CALIFORNIA COASTAL COMMISSION

ADDENDUM

SUBJECT: ADDENDUM TO ITEM F14E, CDP APPLICATION NO. 5-20-0446 FOR THE

City of San Clements Via Ballena Landslide Repair, San Clemente, CA

Exhibit 3 – Open Space/Habitat Use Figures

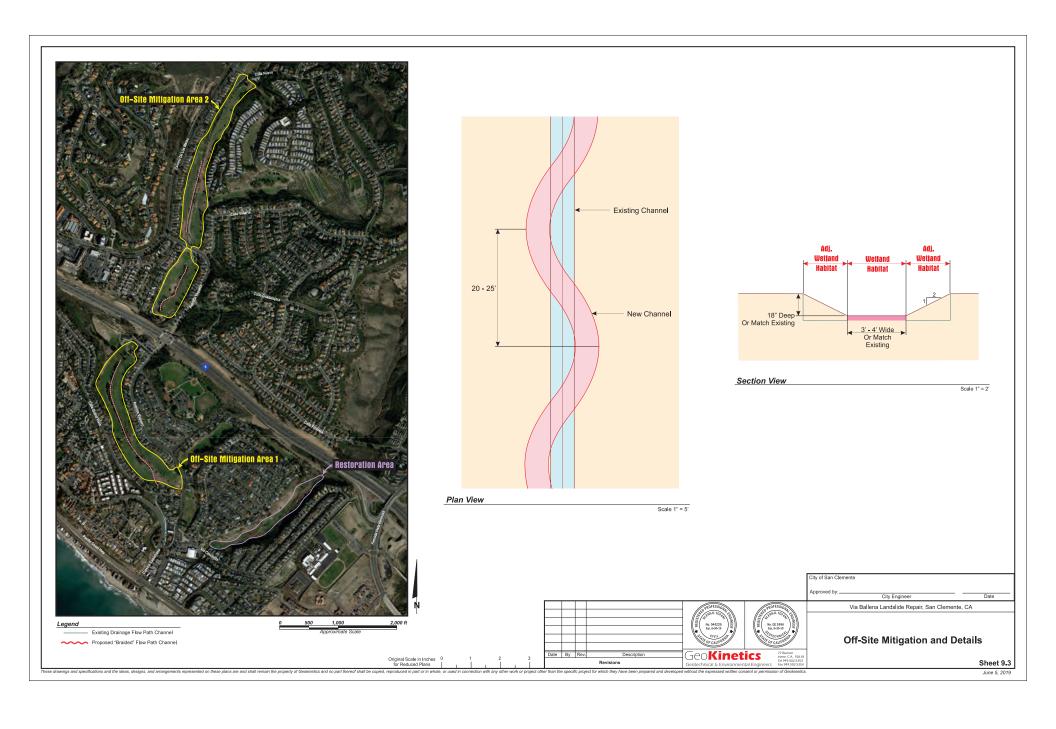
- n) Correct **Exhibit 3** to include additional parcel delineations and a clarification on which parcels are not included in the subject permit on page 9 of Exhibit 3, attached.
- o) Correct **Exhibit 3** to include additional parcel delineations and an additional APN on page 10 of Exhibit 3, attached.

Location	APN(s)	Total Restricted Area
Project Site	691-021-01	4.62 acres
*Off-Site Mitigation Site 1	691-231-06	3.52 acres
*Off-Site Mitigation Site 2	680-041-53 680-011-63 680-011-64 680-041-24	3.75 acres

^{*}Off-Site Mitigation Sites 1 and 2 are referenced as Off-Site Mitigation Sites 2 and 3, respectively, in the applicant's submitted plans.
